**EXECUTIVE SUMMARY OF
Chapter 527 Submittal for Fairfax County Comprehensive Plan Amendment
TYSONS CORNER URBAN CENTER**

**EVALUATION REPORT OF
Chapter 527 Submittal for Fairfax County Comprehensive Plan Amendment
TYSONS CORNER URBAN CENTER**

Fairfax County's Chapter 527 submittal for Fairfax County Comprehensive Plan Amendment, Tysons Corner Urban Center, consisted of an initial report, received by VDOT on December 23, 2009, and four supplemental submissions received between January and March 2010. The original submission presents a good summary of the process, goals, and various transportation analyses that relied on state-of-the-practice models and assumptions guided by experienced professional staff. To help organize our review comments we prepared a Table of Content of the initial submission, included below. Our review follows the order in the table; Section and subsections added by VDOT to address specific areas are listed in italics.

Figure 17-4 Work trip rail mode share by distance to office sites from station

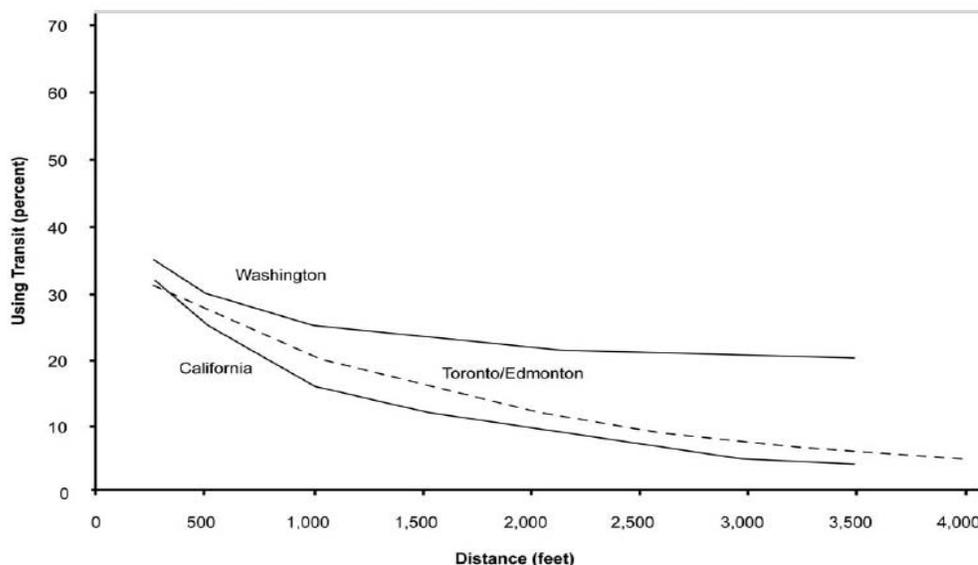
A review of Table 3 of the 2005 Development-Related Ridership Survey (Washington Metropolitan Area Transit Authority) indicates a commute transit share (Metrorail, Metrobus and other transit) of approximately 34% for the 17 office sites surveyed, located on the average within 1/5 mile of stations (varied locations within CBD and Suburban sites inside and outside the Beltway). Table 4 in the same report indicates that office sites in CBD areas (within D.C. borders) will have much higher transit shares, while those in Suburban-Inside the Beltway have transit shares in the 30% range. The subject submission also identifies TCRP Report 95, Chapter 17; the figure below from that report provides another glimpse of work trip transit share as a function of distance from stations; relative percentages are higher for Washington D.C. (Central Business District).

Residential peak period transit share is anticipated to be higher than those for work trip destinations, as people who chose to pay the typically higher prices of residences near rail stations are also much more likely to use transit for their work and other trips. This effect can be seen in Tables 9 and 10 in the 2005 Development-Related Ridership Survey mentioned above, which indicate an average transit share of 45% (18 sites, average distance of about 2,000 ft. from stations) and 50% for sites classified as Suburban- Inside the Beltway.

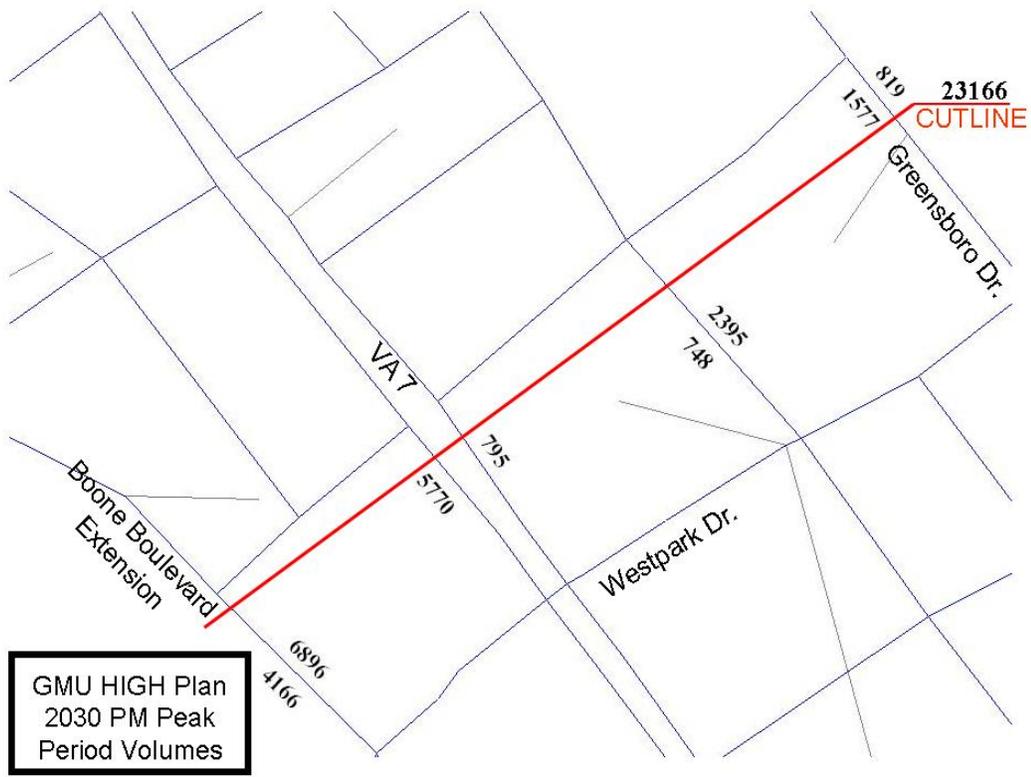
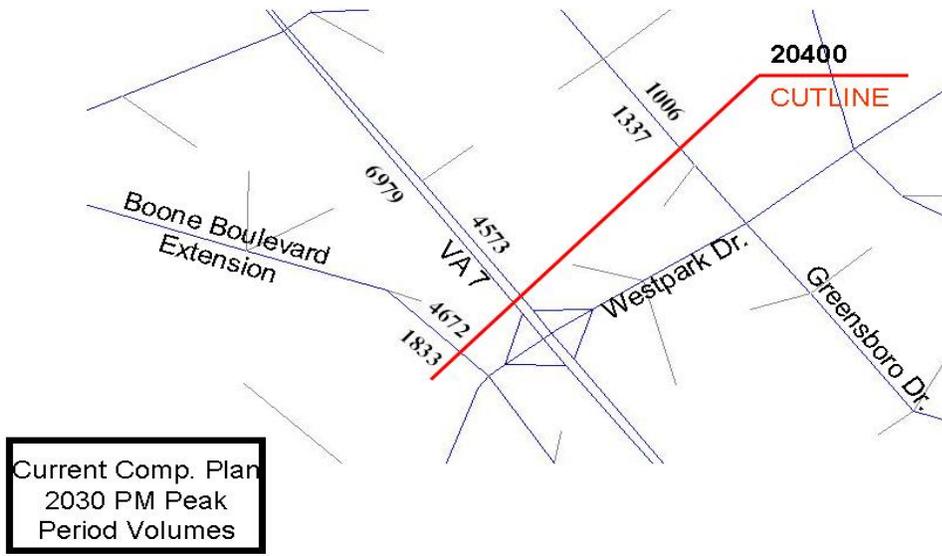
Comparison of the selected results reveals that PM peak period volumes per lane are comparable for both models (2,900 for GMU High versus 2,706 for MWCOG). The main difference between the models is the higher V/C ratios for MWCOG relative to its lower volumes, when compared with the GMU High model which shows lower V/C ratios (better segment performance) with similar or even higher volumes. For Route 7 between Idylwood Rd. and Magarity Road, this difference can be partially attributed to the added capacity under the GMU F conditions (6 vs. 4 lanes). For the other segments however, the differences are unexpected. County/ consultant response indicated that the two major differences between the COG and GMUF networks that impact the traffic assignments are (1) a large difference in the number of zones and thus zonal access points and (2) the grid of streets. However, these factors do not address why a higher traffic volume within a road segment results in a lower volume/ capacity ratio. We understand the County’s proposed Comprehensive Plan model incorporate added subzone network detail, 12 different assigned road classifications (7 in the MWCOG model), starting capacities assigned in the County’s model to each of the 12 road classifications, and modifying factors to reduce/adjust capacities. However, working back from the values in the above tabulation, the conclusion is that the assumed underlying unit lane capacities (vehicles per hour per lane) are significantly higher in the county’s model, compared to the MWCOG model.
